System Impact Assessment Report

Markham MTS #4

**Final Report
CONNECTION ASSESSMENT &
APPROVAL PROCESS**

CAA ID 2008-320

Figure 2: Markham MTS #4 Station Diagram

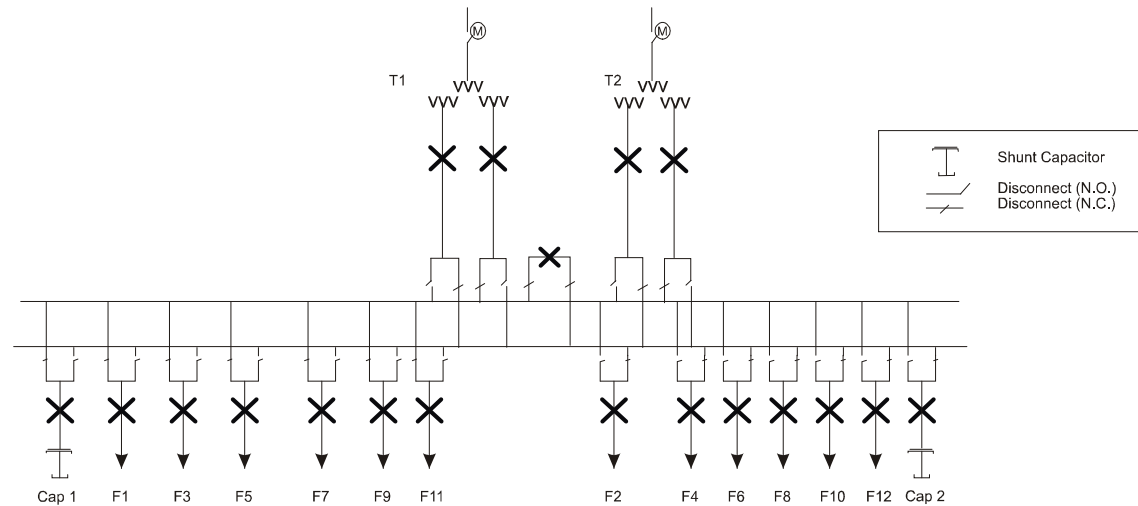
The diagram that was provided by the applicant shows each transformer being separated from the transmission system via a motorized disconnection switch. For this particular arrangement the Transmission System Code requires that transfer trip of the Transmitter's breakers at the terminal stations be provided for transformer faults. In the case of Markham MTS #4, which is to be connected to the 230 kV lines P45 and P46 the transfer trip must be sent to Parkway TS of the faulted circuit.
